**Response to Request for Information – Contamination Issues**  
**Northern Beaches Business Park - Proposed Warehouse Unit #1 (DA2021/2608)**  
**4-10 Inman Road, Cromer, NSW**

**Project No: 26.01 Rev0**

### **Proposed Development Plans**

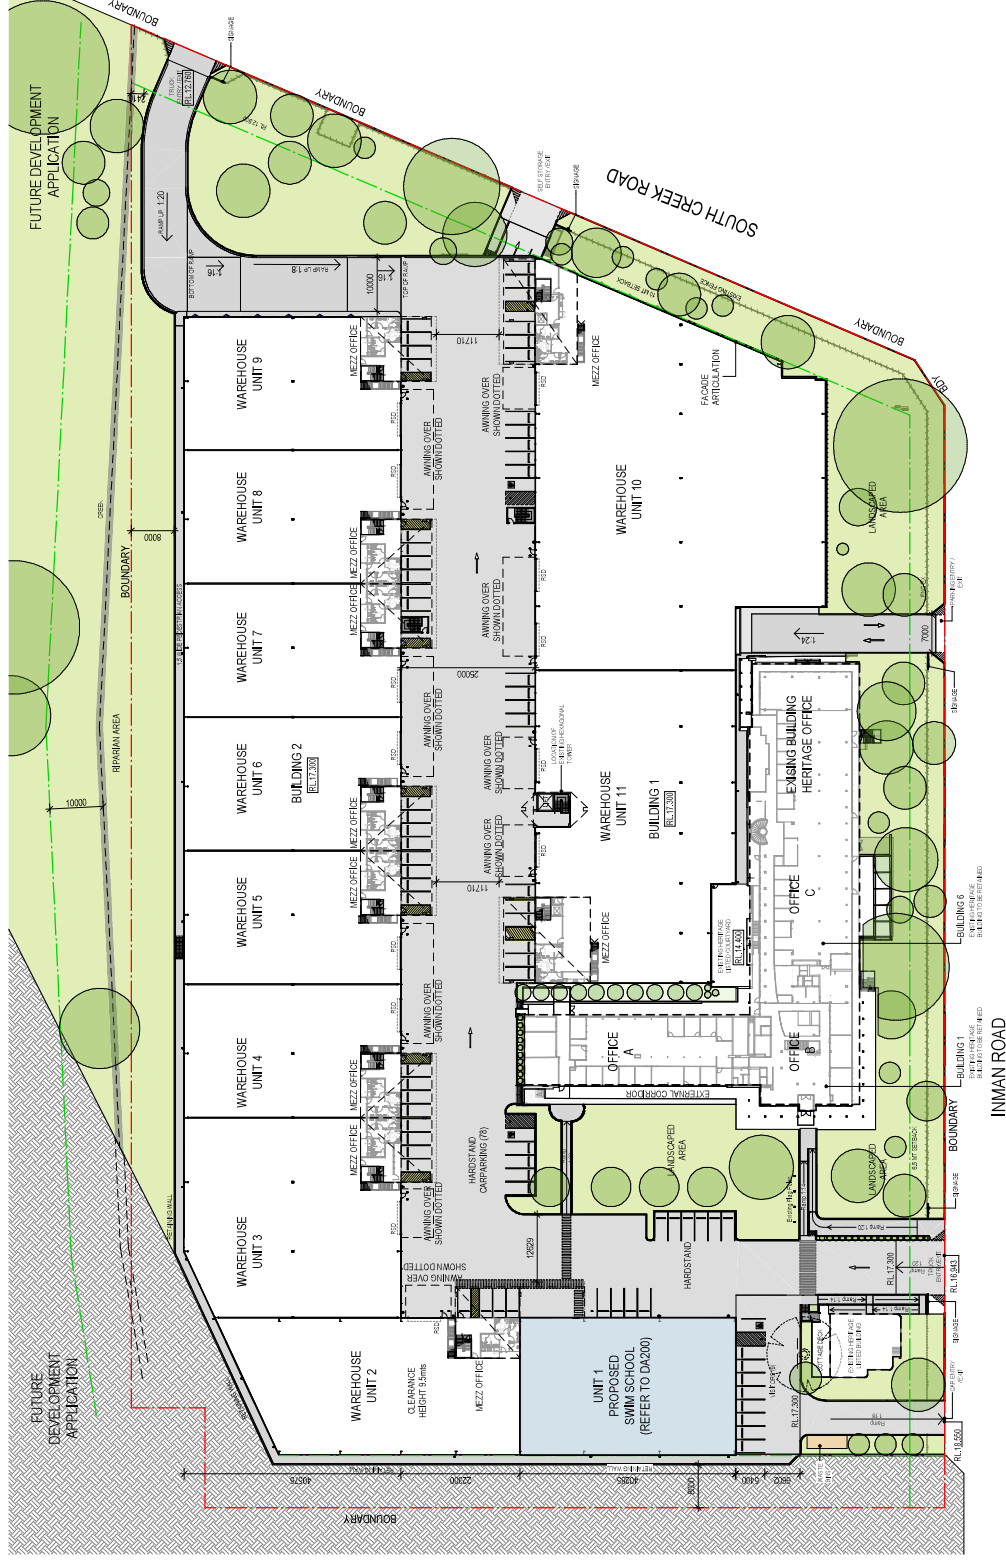
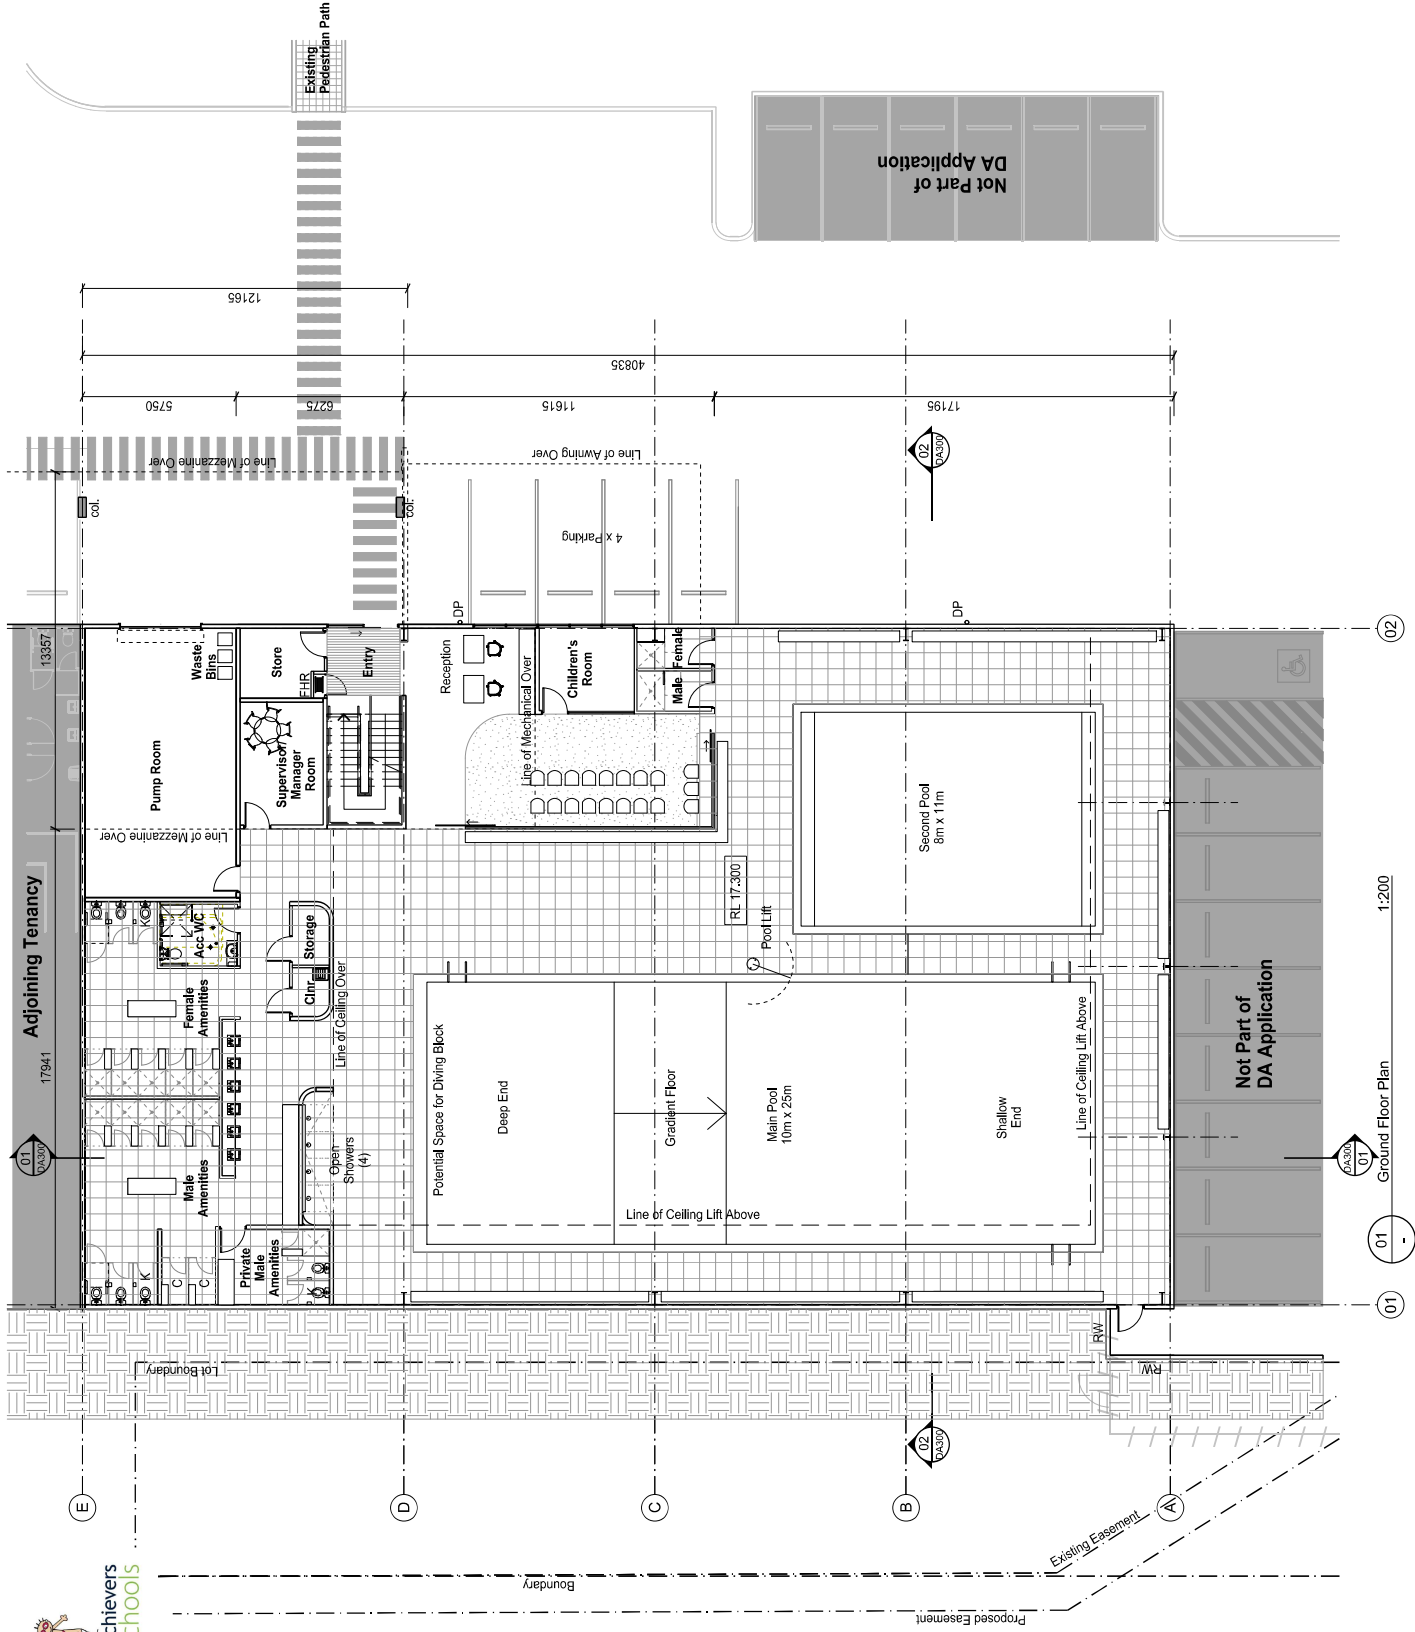
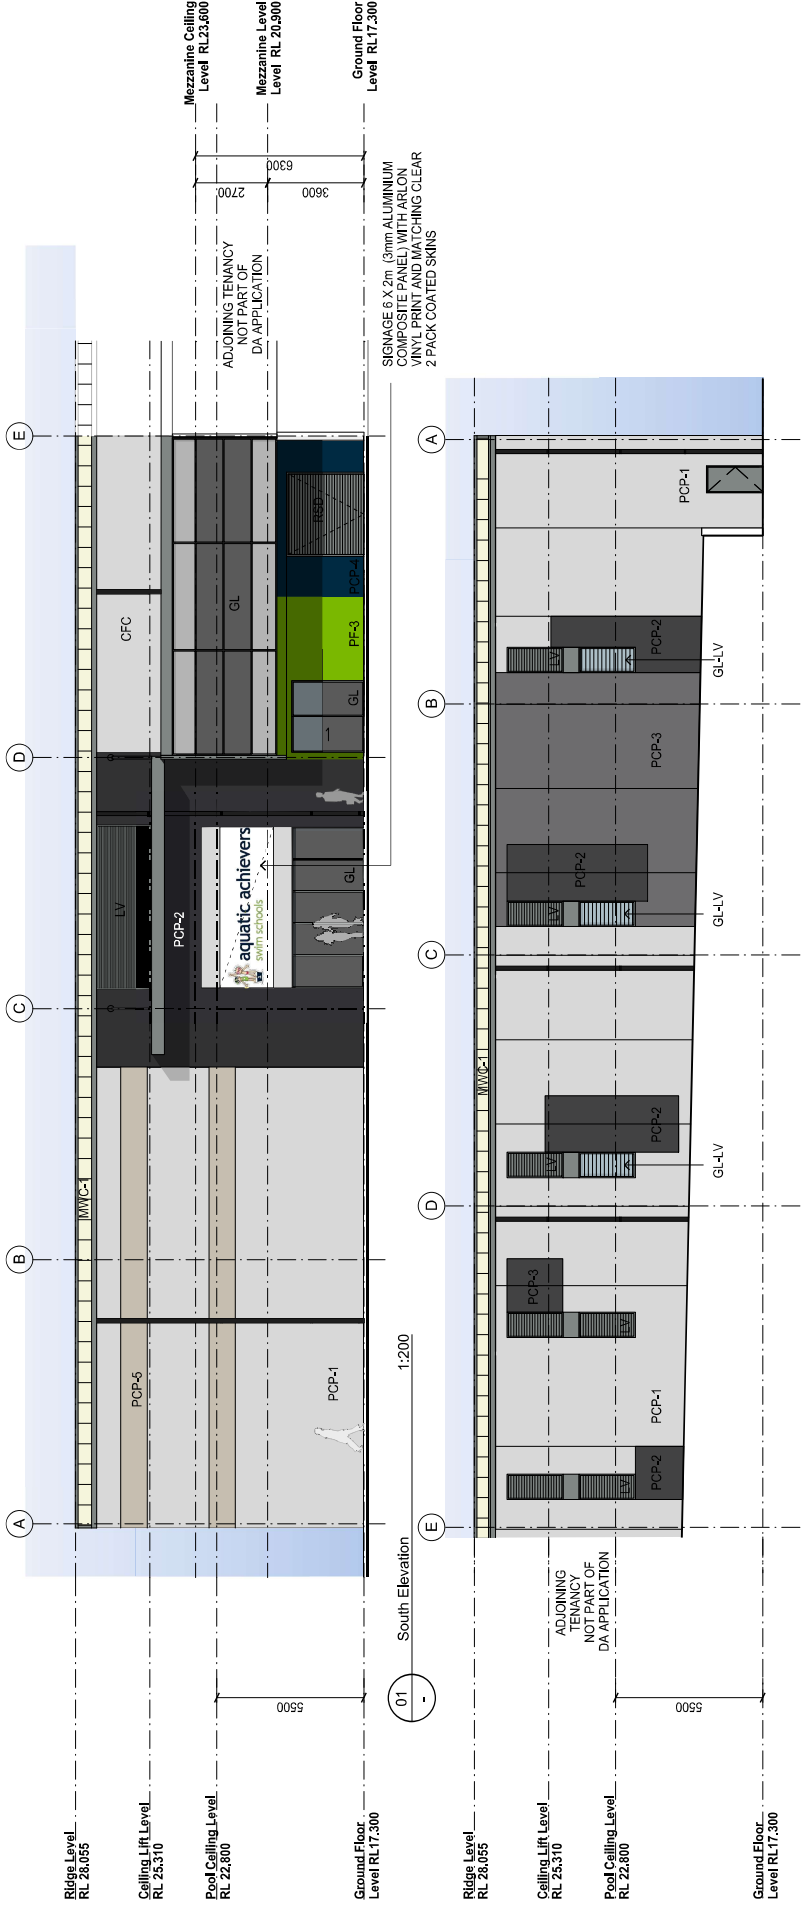
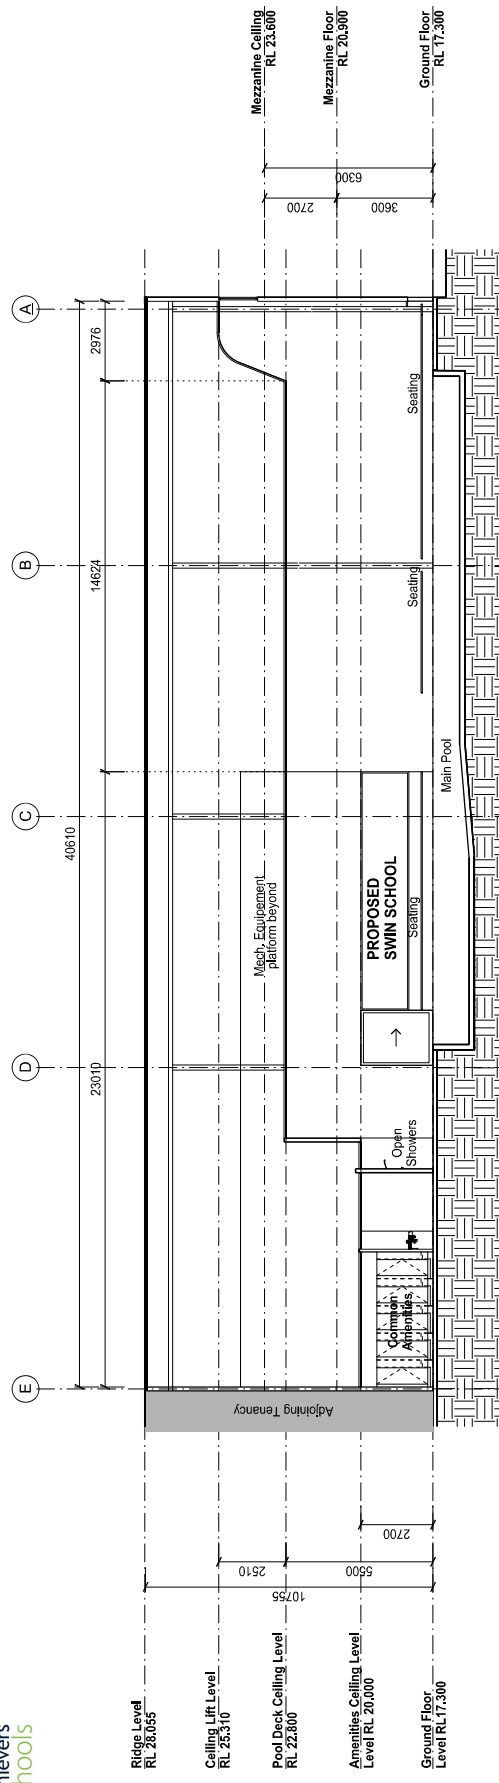
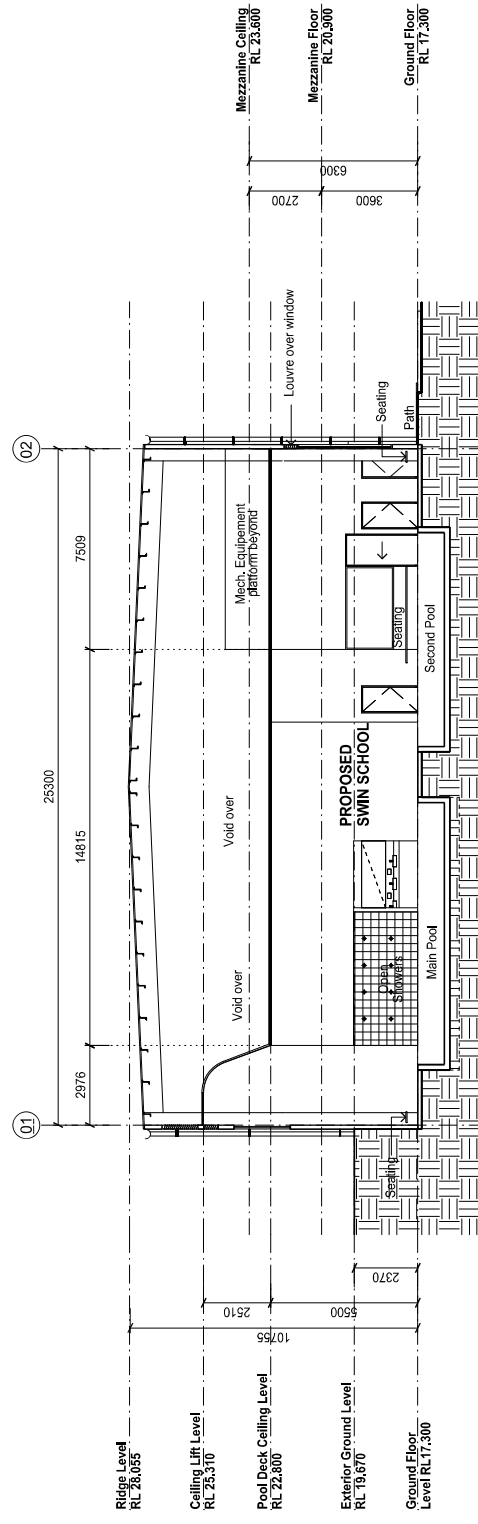
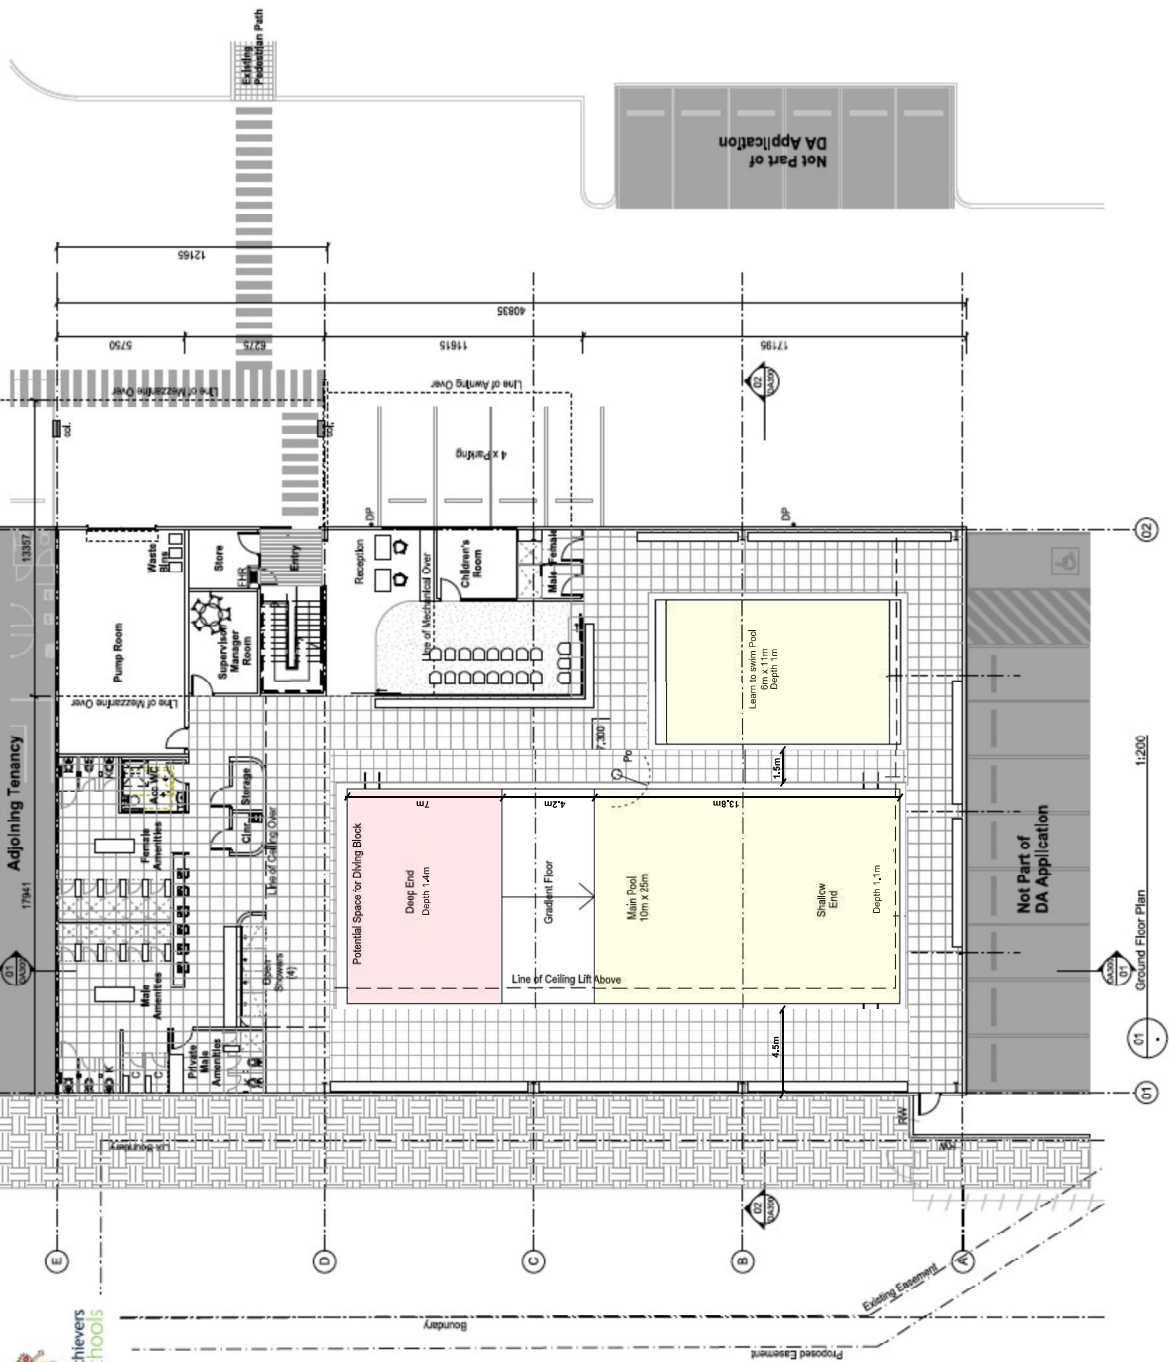
- *The EPA seeks clarification on the depth to be excavated to construct the swimming pools. It is not clear on the provided figures what the final excavation depth will be. I.e. not the final pool depth, but the actual depth required to be excavated. It is noted that groundwater at the site is relatively shallow, and is expected to be shallower than previously reported, due to the higher than average rainfall recently. No groundwater monitoring results have been provided in this area for some time, and given the recent heavy rainfall, groundwater depth will be relatively shallow.*

The design plans (**Attachment A**) indicate a maximum pool depth of approximately 1.4m, with an additional 300-400mm of excavation to accommodate the pool floor. However (and as documented in the above responses), regardless of the required excavation depths (and potential high groundwater levels from excess rainfall), the risk for potentially encountering contaminated groundwater at this portion of the site is considered to be low, and if contaminated groundwater is impacted, there are sufficient management procedures in place (as documented in the CDMP) to investigate and manage these impacts.
